FT5000 X-SCALE FAN ASSEMBLY ADAPTER CABLE

The following illustrations show the adapter cable (P/N 09120-00721) included in FT5000 upgrade kit (P/N 06200-00101) for customers field upgrading an FT unit from a dip reader to motorized card reader.

5x2 to 4x2 adapter cable

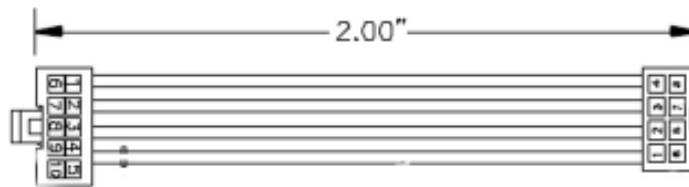
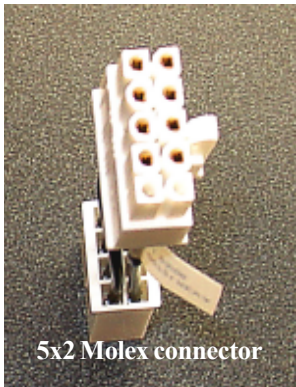
After completing the motorized card reader upgrade, they will have too many devices to plug into the units power supply. They will need this adapter cable (09120-00721) to connect to the fan and use the 5x2 outlet on the power supply normally reserved for TDM dispensing mechanisms. This will free-up a 4x2 outlet for the motorized card reader.
